## **ADDENDUM NO. 3**

### Project Name: INDIAN RIVER COUNTY MAIN LIBRARY ROOF REPLACEMENT (IRC-1838)

Bid Number: **2020029**

STAGING/LAY DOWN AREA LOCATION MAP

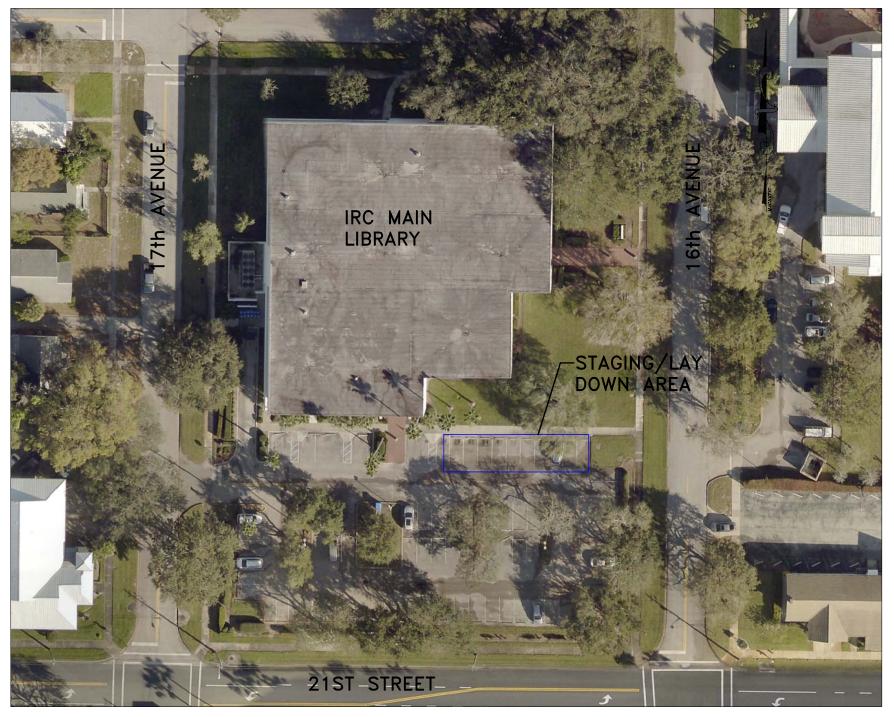
**Question 3.** This question was asked at the on-site pre-bid. What would be a good laydown/staging area. **Answer:**

#### See attached map of laydown area.

N N N L δ  $\mathbf{O}$ С C  $\mathbf{O}$ Ш Щ RI< INDIAN RI ROOF 1600 VERO PRO Ш  $\mathbf{\gamma}$ 838 7 IRC REVISION # REVISION DATE 03-11-2020 05-15-2020 3 SCALE: AS NOTED DATE: 12-04-2019 SHEET DESCRIPTION: **BUILDING CODE** REI PROJECT NO: 019TPA-027 SHEET: **R**2

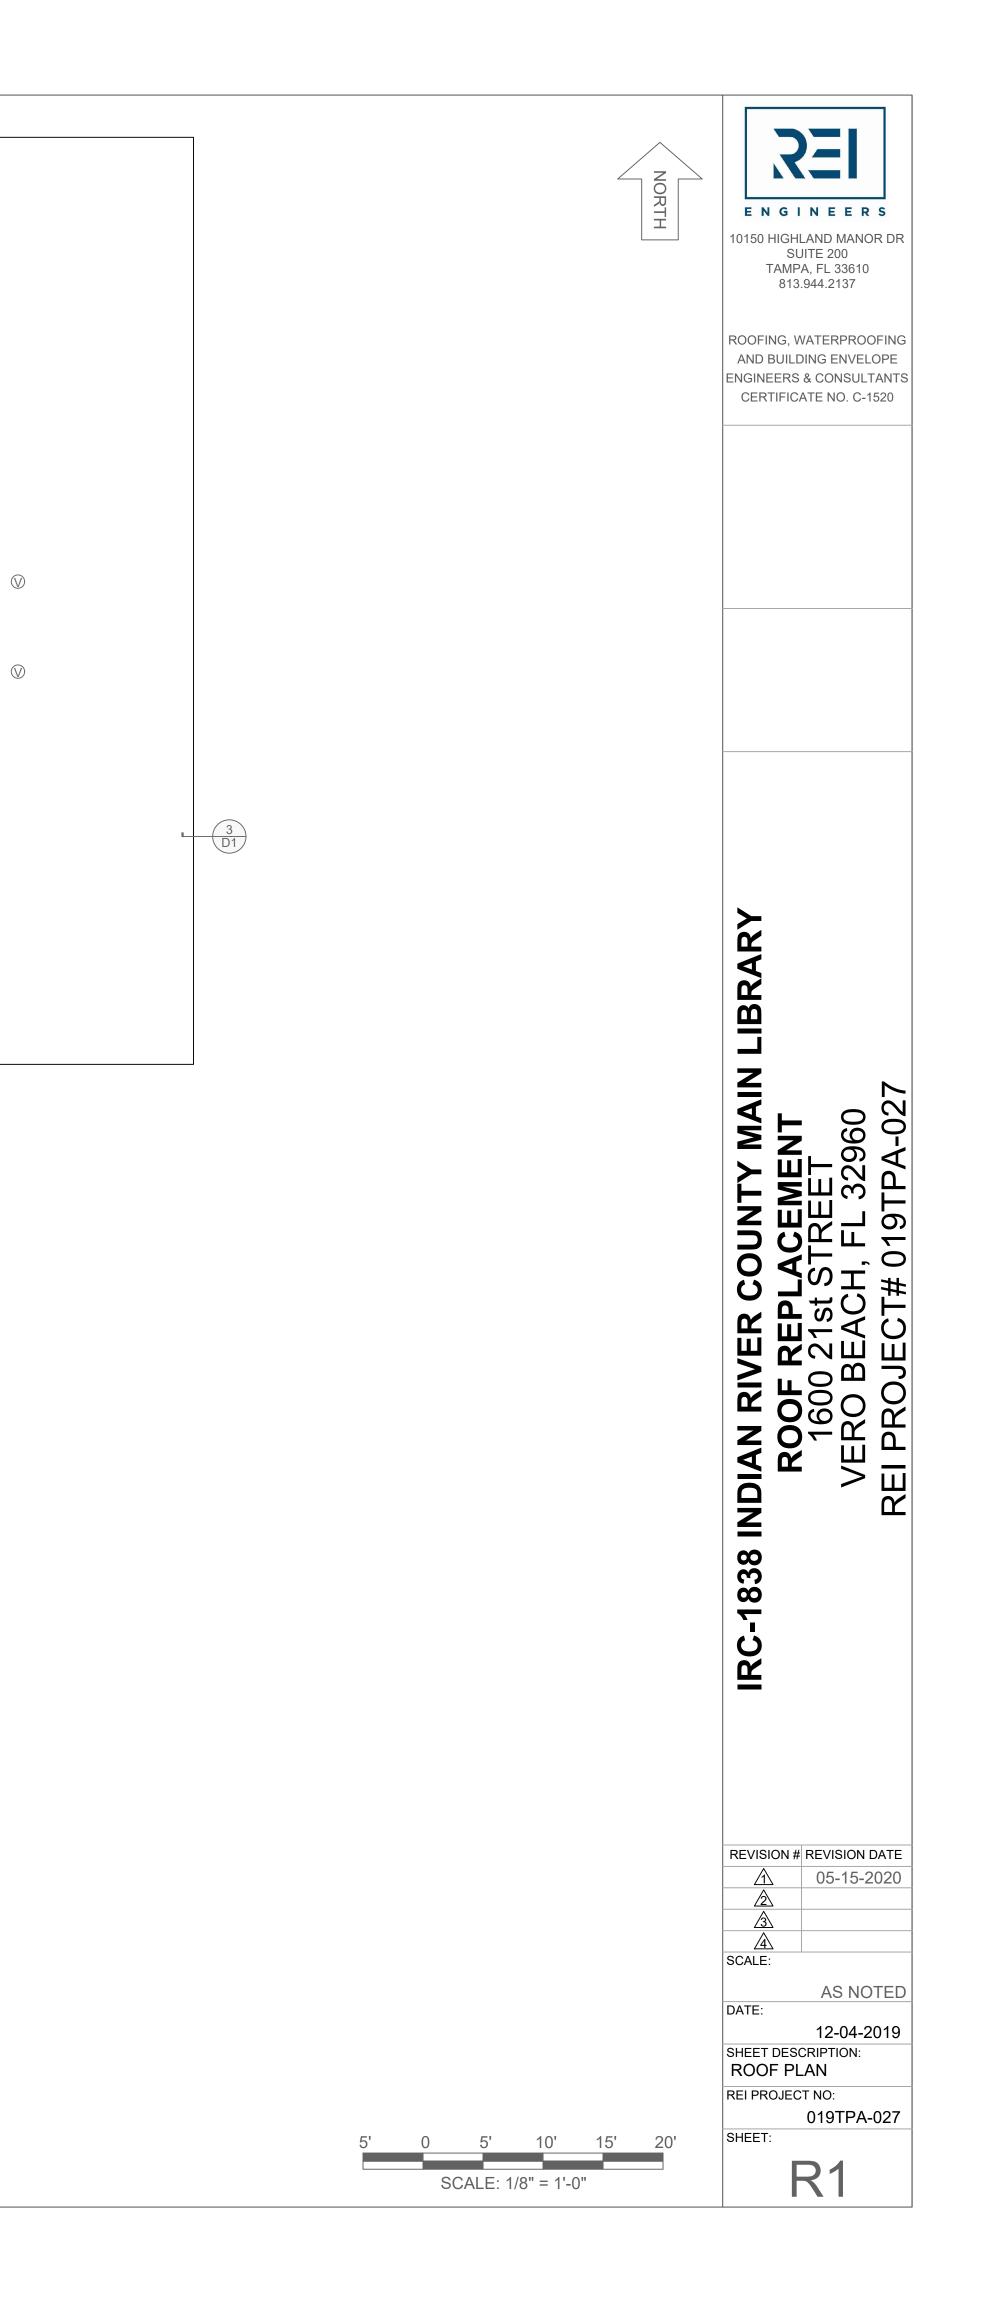
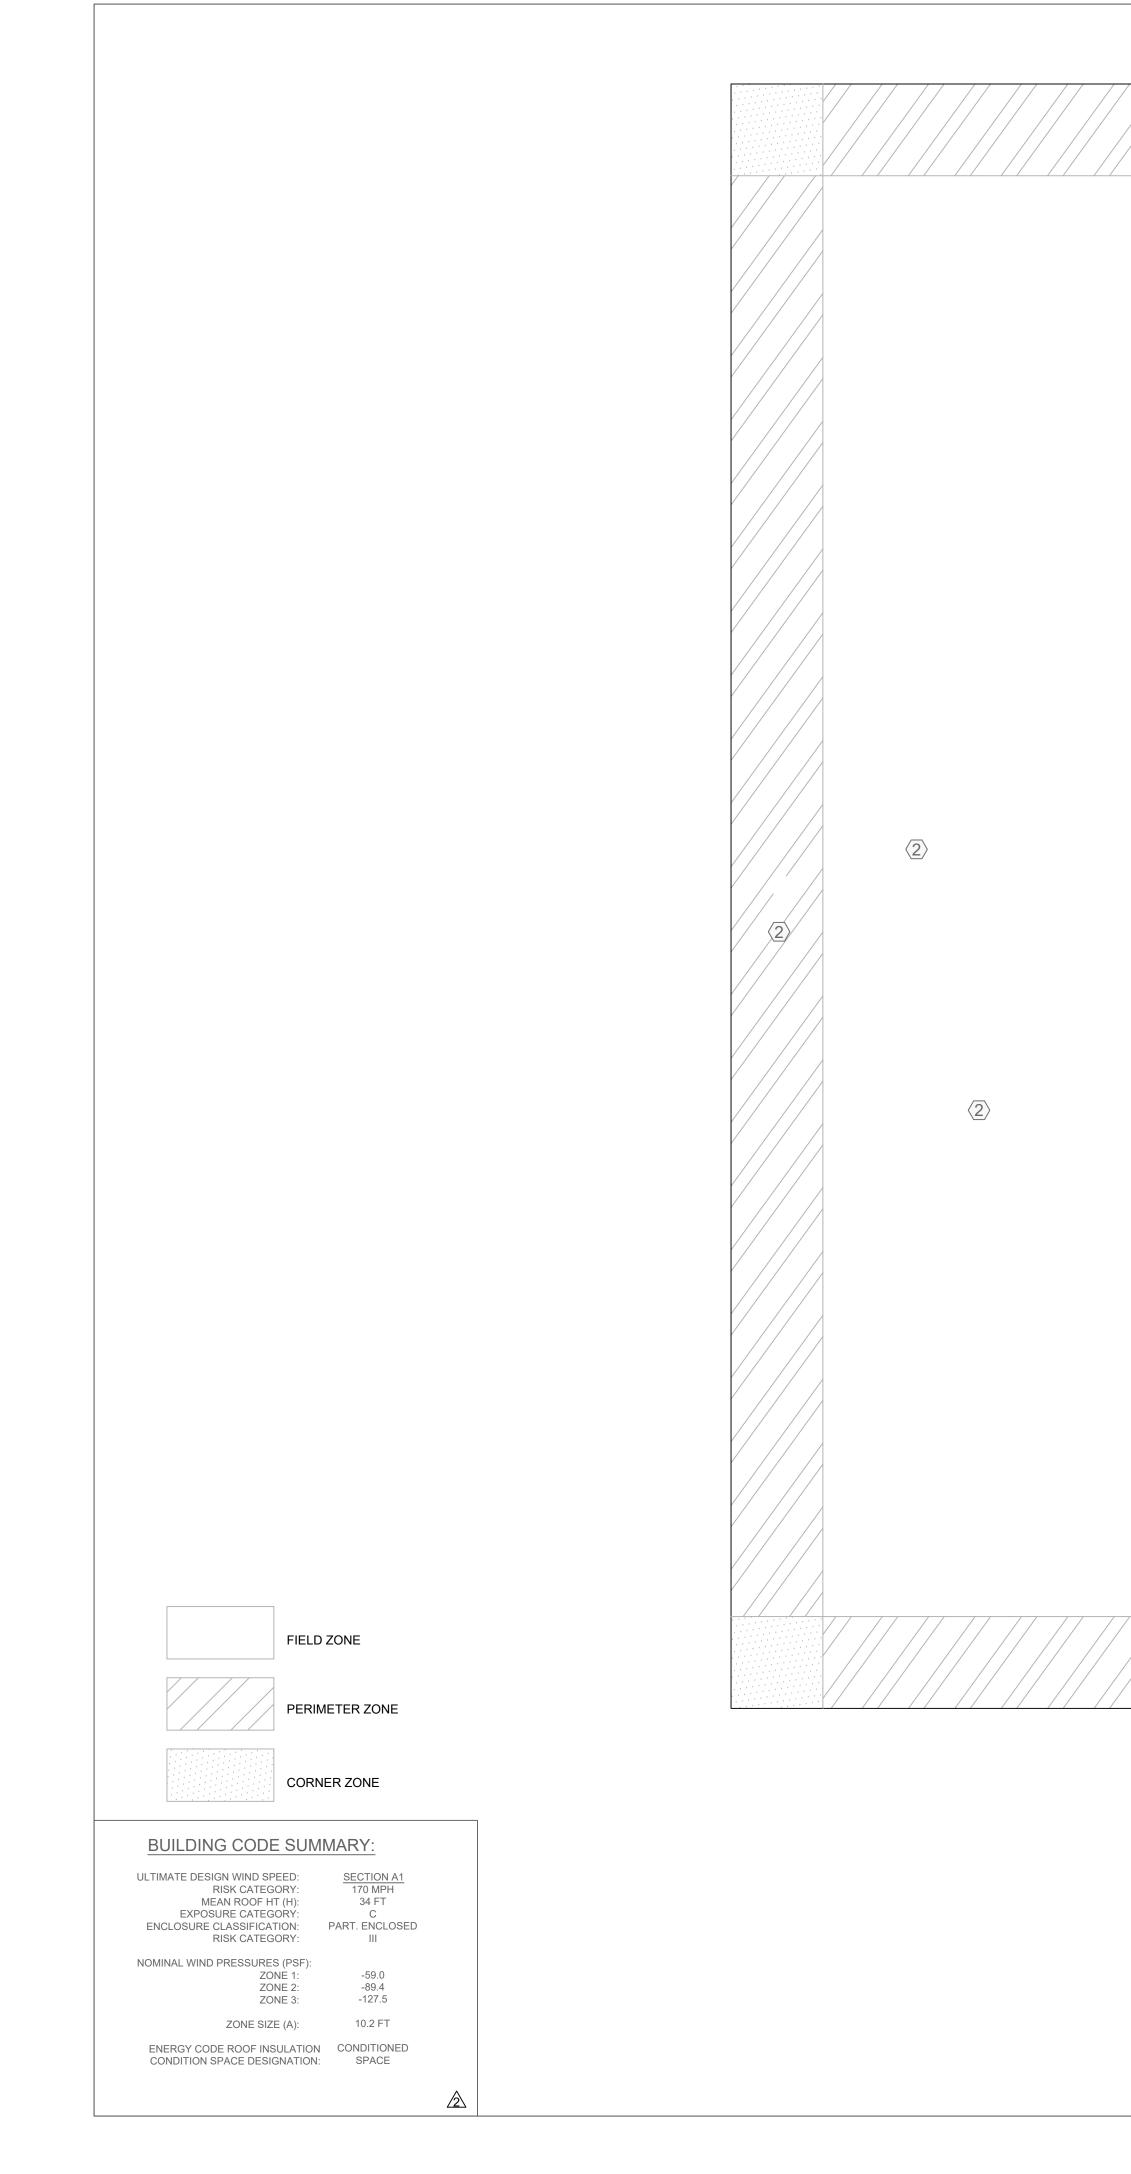
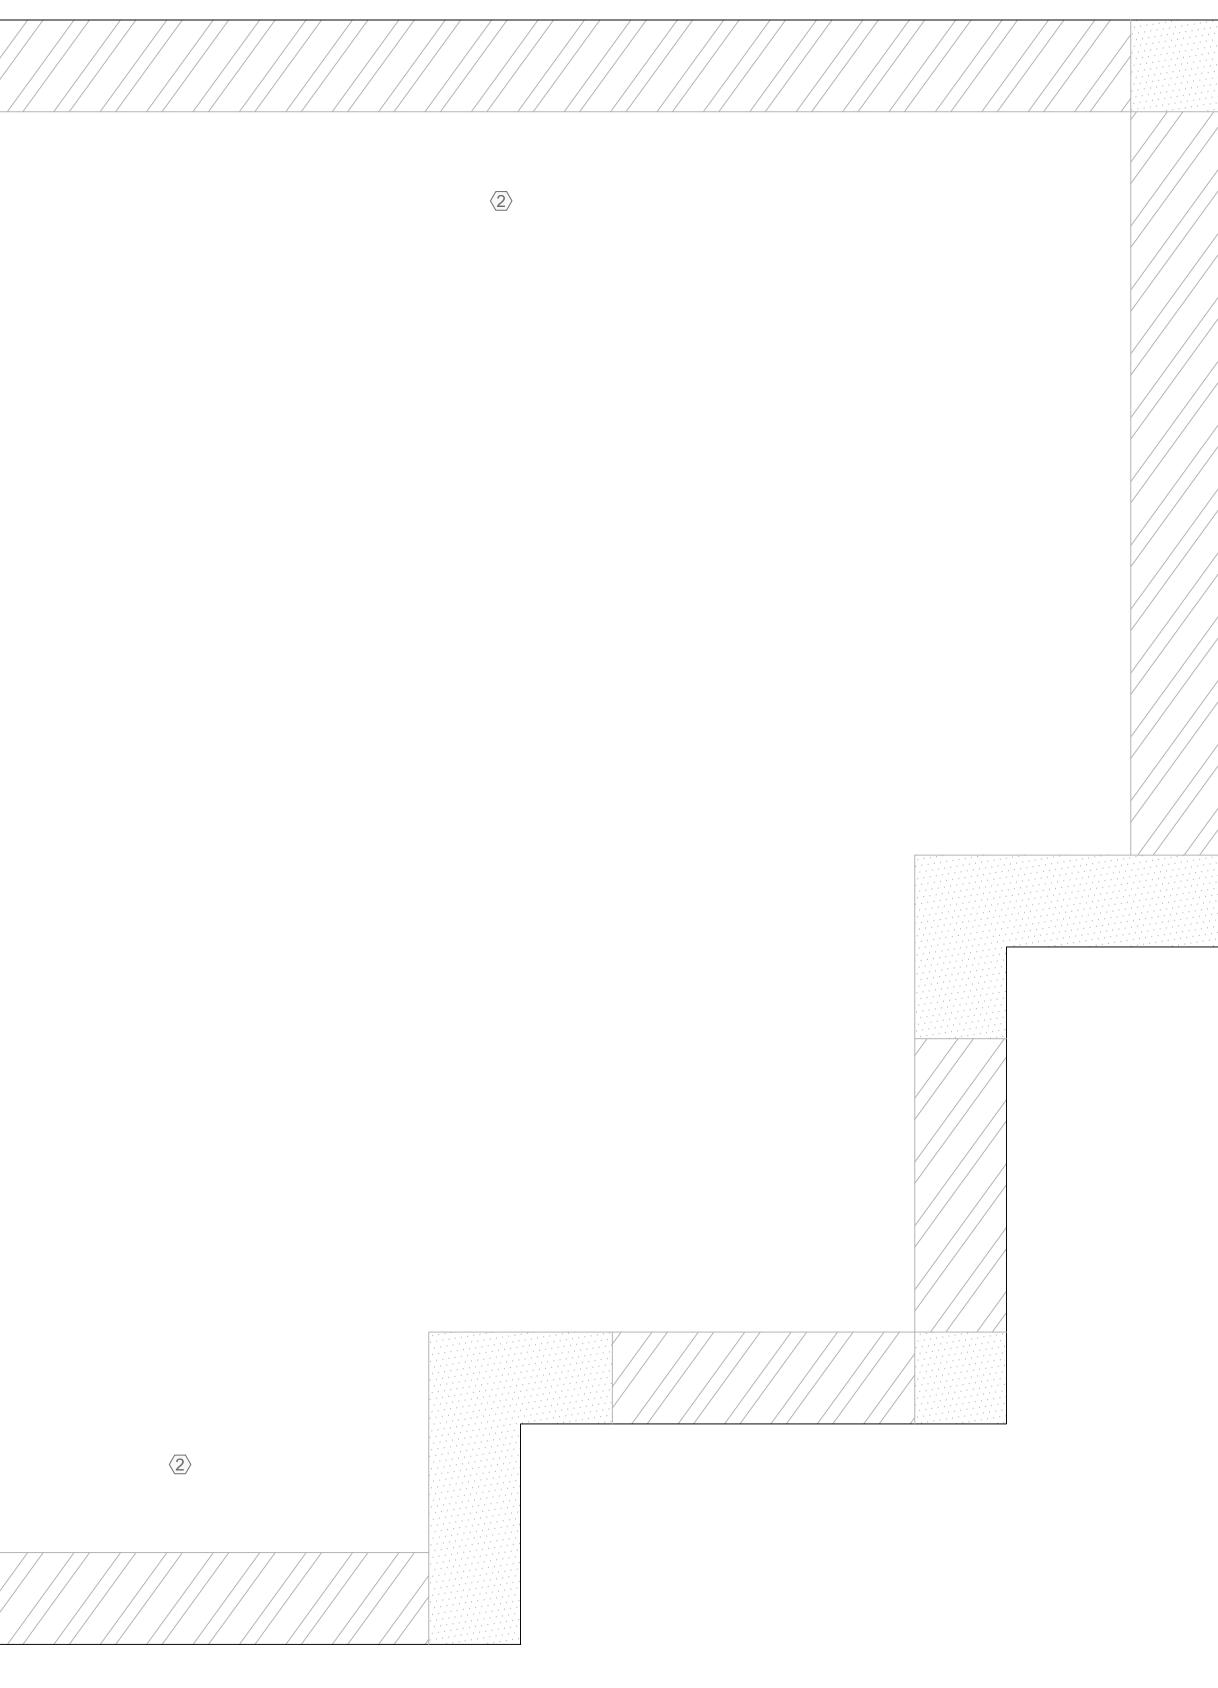
Question 10. Drawing Sheet R2- Building Code Summary states Ultimate Design Wind Speed 170 MPH. Are the wind pressure listed below that heading, the Ultimate Design Pressures? Or are the wind pressures listed below that, the Nominal Design Pressures as that will make a difference in the fastening patterns and ability to receive an NOA as far as I am aware of.

**Question 11.** Are the uplift calculations on the bottom of Roof Plan R2 ultimate or nominal? Can they be factored by multiplying by .6?

- 6. Replace Specification Section "Contract Drawing R2 (Revision No. 1)" with attached "Contract Drawing R2 (Revision No. 2)". Contract drawing has been updated to clarify wind pressure designation.

The wind pressures noted on the drawing are service load nominal wind pressures and are not eligible for further reduction. Please reference addendum 03 which clarifies wind pressure nominal status.

The wind pressures noted on the drawing are service load nominal wind pressures and are not eligible for further reduction. Please reference addendum 03 which clarifies wind pressure nominal status.
